To: T10 Technical Committee
 From: Rob Elliott, HP (elliott@hp.com)
 Date: 23 December 2005
 Subject: 05-381r1 SAS-2 Multiplexing

Revision 1 (23 December 2005) Incorporated feedback from SAS protocol WG teleconference - removed the algorithm to decide whether or not to multiplex a link (left as vendor-specific), added more non-multiplexing specific changes to support 6 Gbps throughout all but the physical layer chapter.

Figure 3 — Phy class diagram

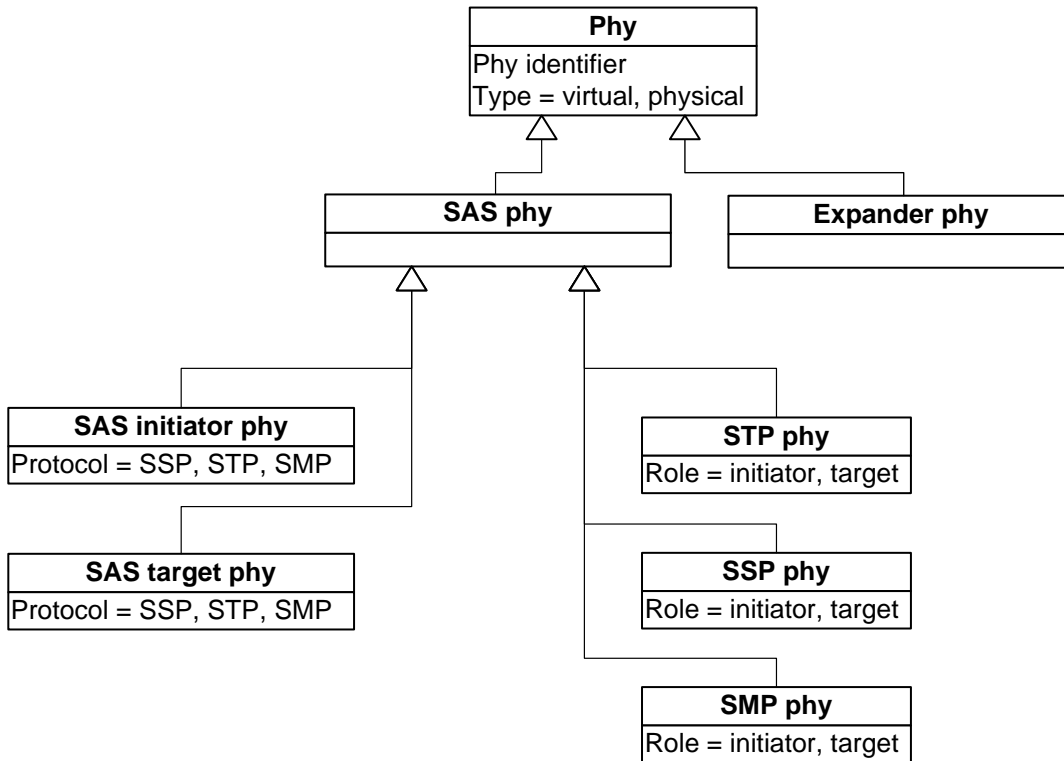
Editor's Note 1: Logical phys need to be included in the UML model, perhaps just as another attribute or a new value in the Type attribute.

Figure 13 — Reset terminology [\[updated to add multiplexing sequence\]](#)

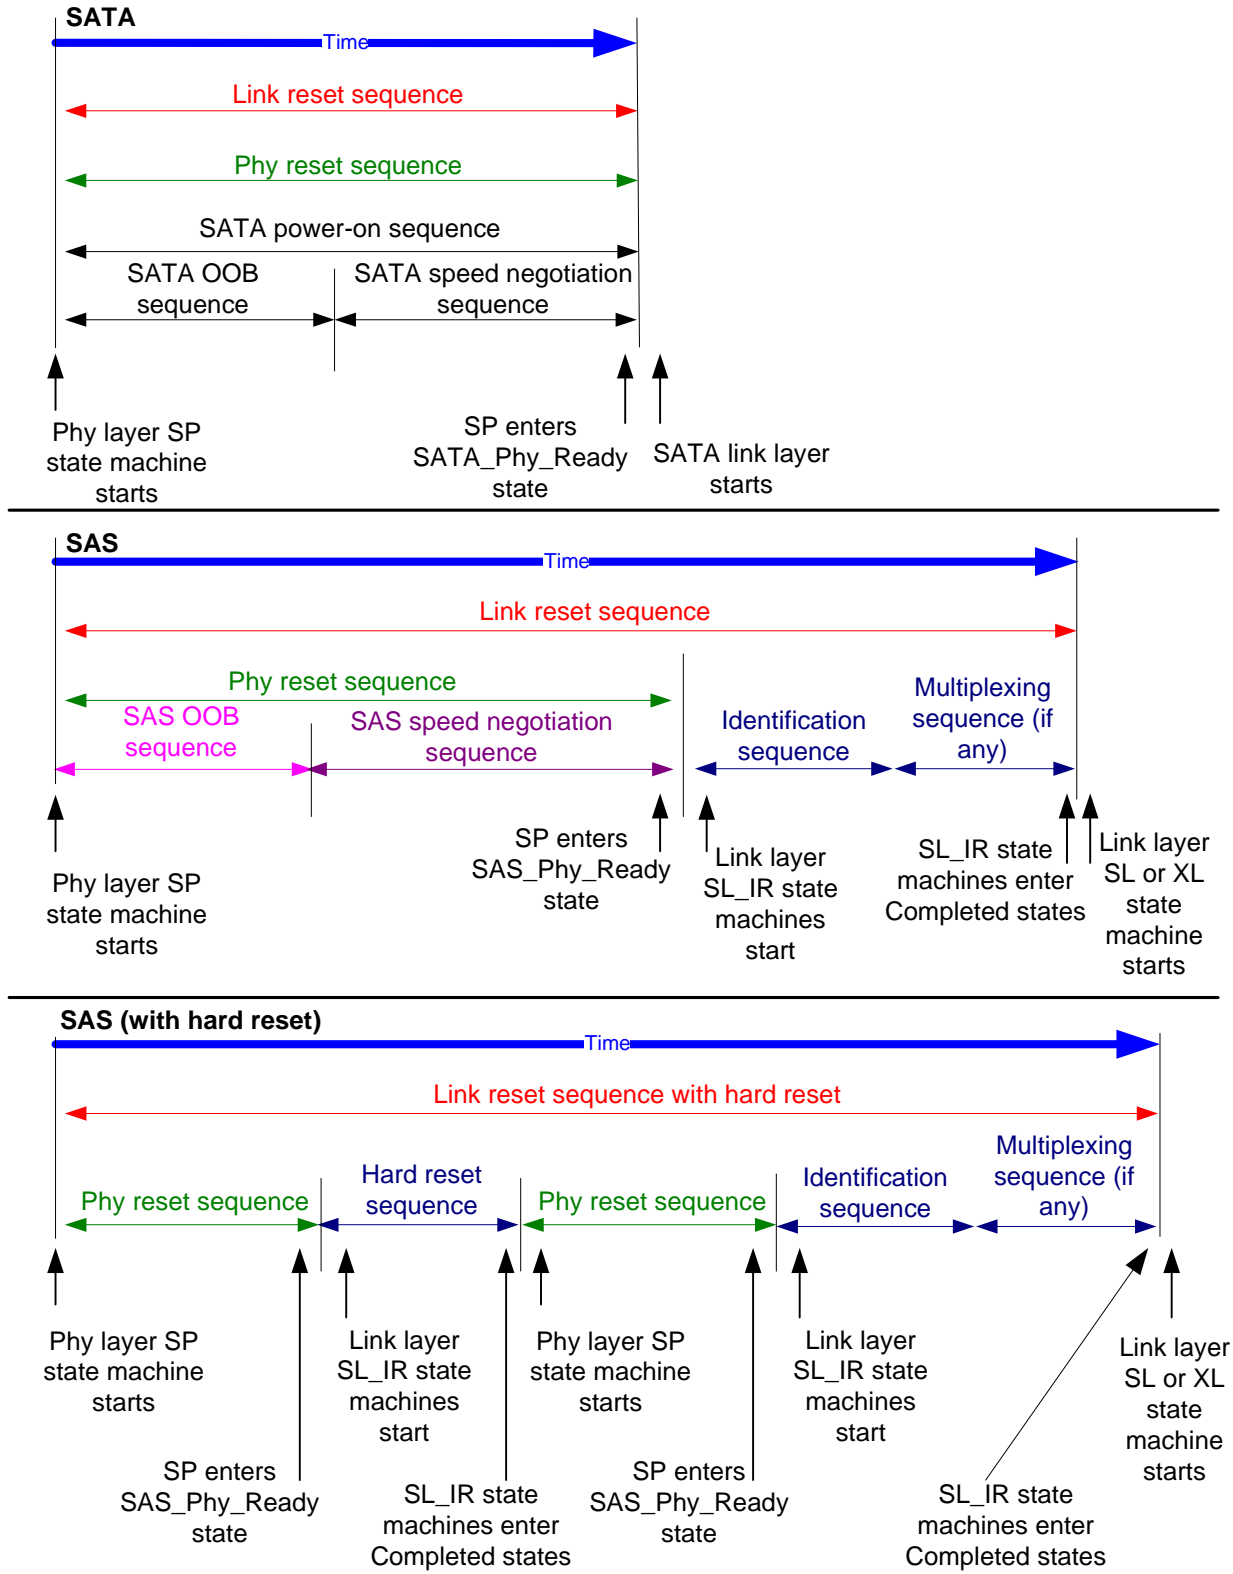
- a) link reset sequence;
- b) phy reset sequence (see 6.7);
- c) SATA OOB sequence (see 6.7.2.1);
- d) SATA speed negotiation sequence (see 6.7.2.2);
- e) SAS OOB sequence (see 6.7.4.1);
- f) SAS speed negotiation sequence (see 6.7.4.2);
- g) hard reset sequence (see 7.9);
- h) identification sequence (see 7.9); [and](#)
- i) [multiplexing sequence \(see 7.x\)](#).

Figure 14 — SL_IR (link layer identification and hard reset) state machines

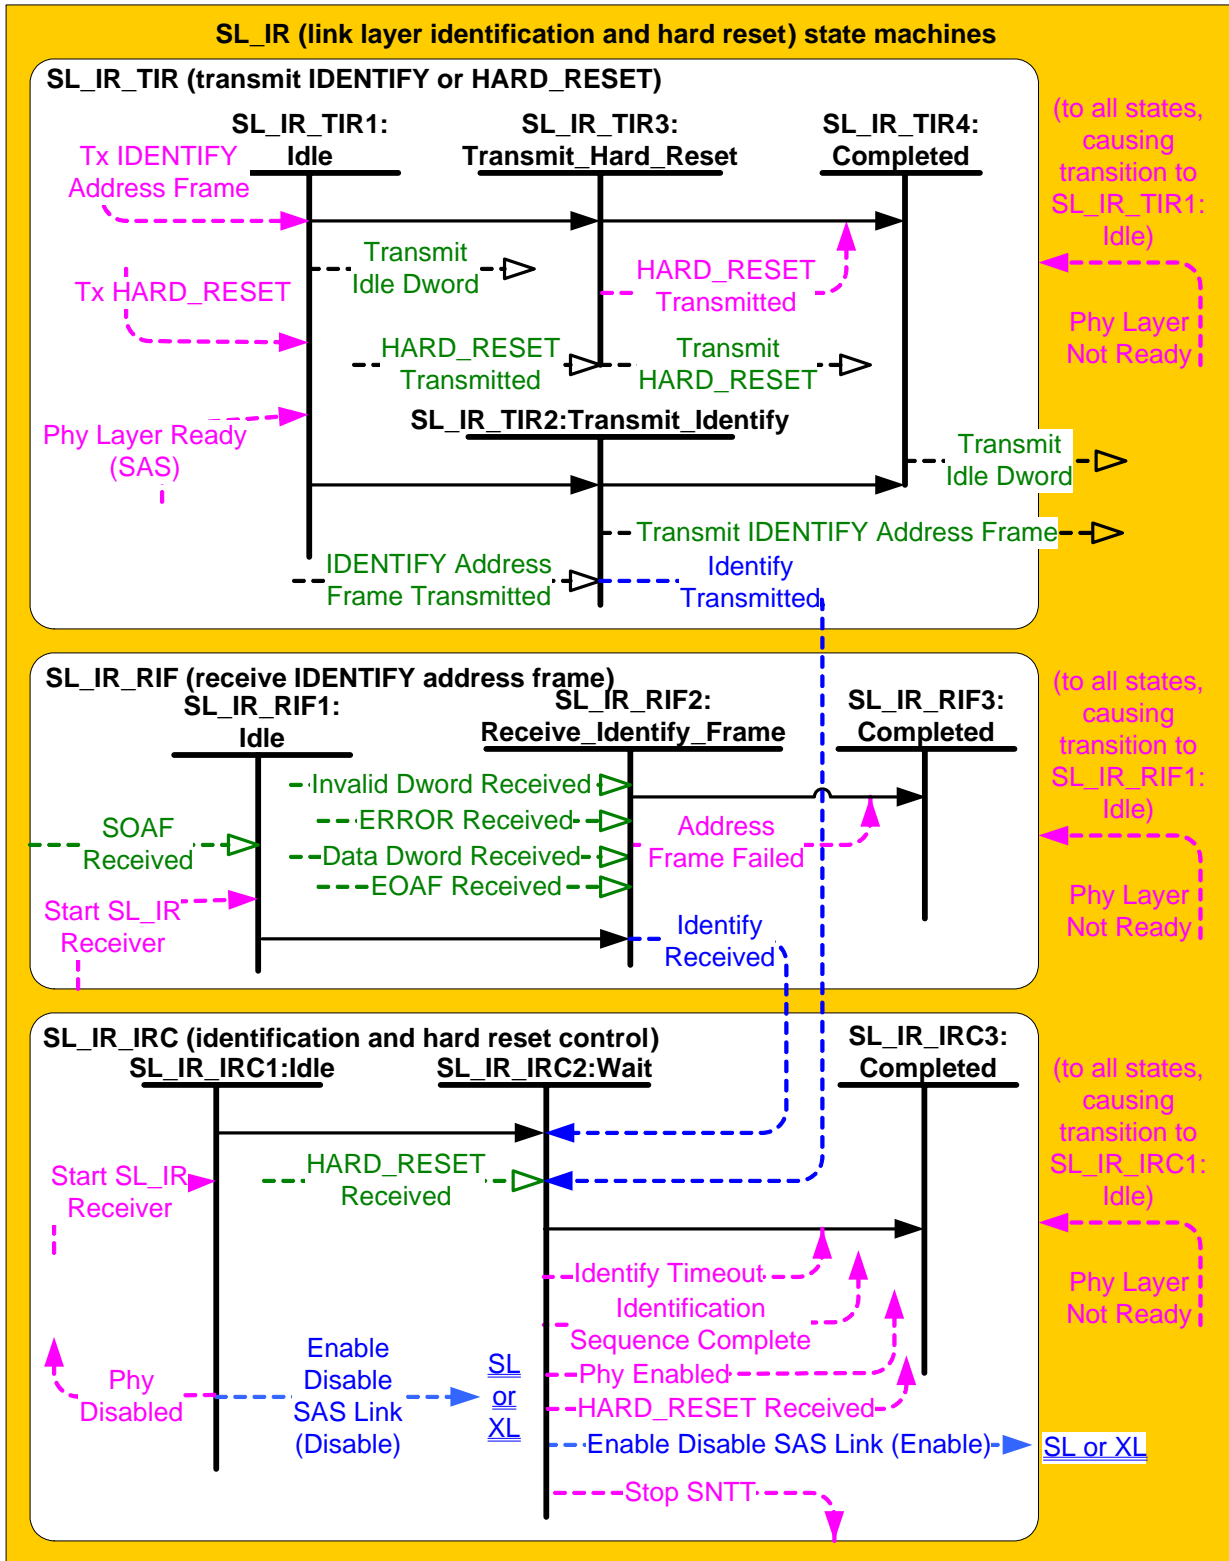
[Editor's Note 3: Probably need to add state\(s\) to handle the multiplexing sequence. Rename this the SL_IRM state machine?](#)

Figure 15 — Multiplexing

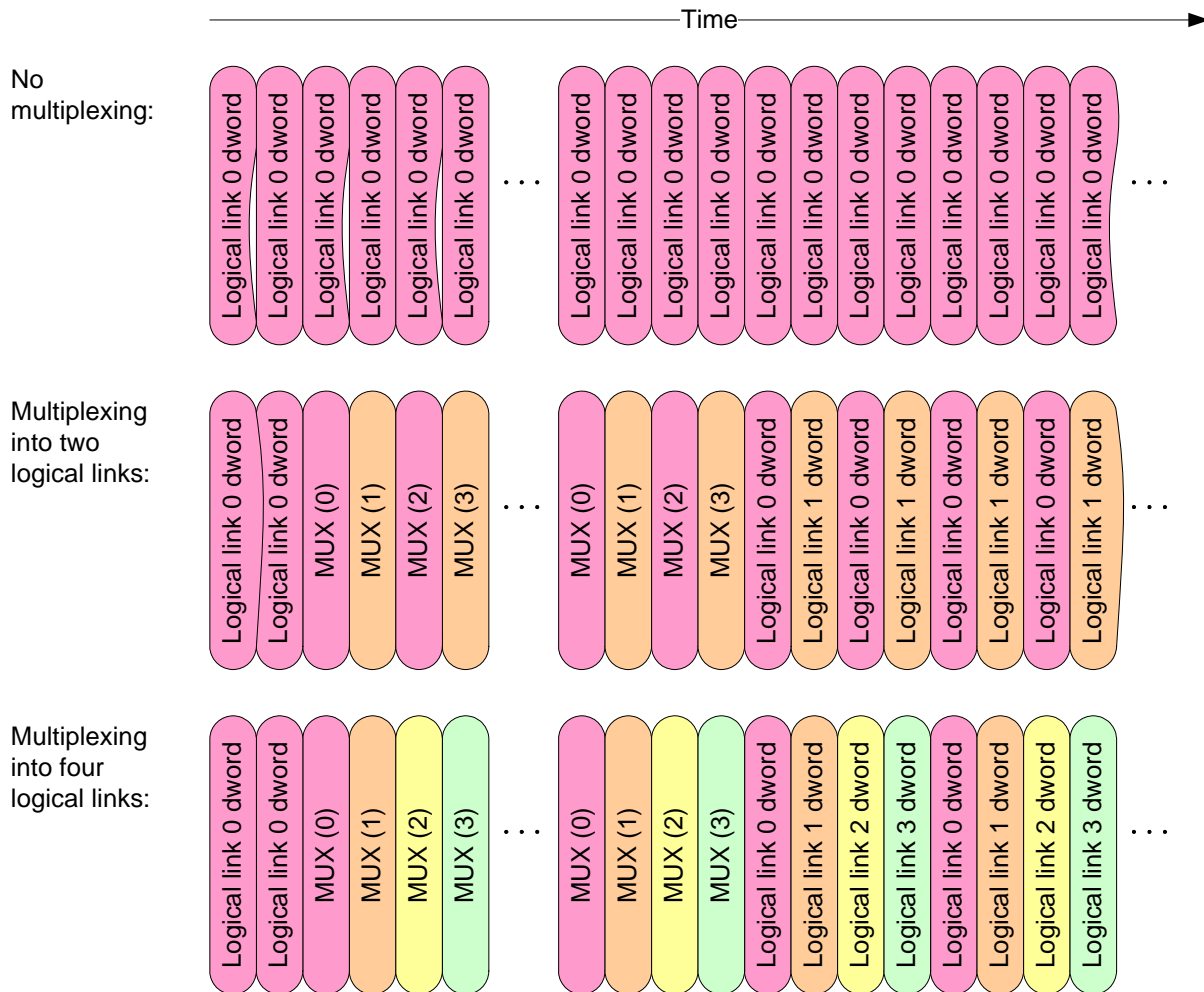
The phy shall transmit MUX repeatedly, rotating through MUX (0), MUX (1), MUX (2), and MUX (3) in order. The phy shall not transmit ALIGNs and/or NOTIFYs during the multiplexing sequence.

After the phy receives at least 3 MUX primitives confirming the position of dwords in each logical link, it shall continue transmitting at least 24 MUX primitives. The phy shall then stop transmitting MUX and the logical phys shall start transmitting dwords for the logical links in the corresponding positions as shown in figure 15.

The first dword in a logical link may be any type of dword (e.g., ALIGN, NOTIFY, primitive, or data dword). Each logical phy shall honor the ALIGN insertion rate rules in 7.xx. The logical phys shall ignore MUX primitives.
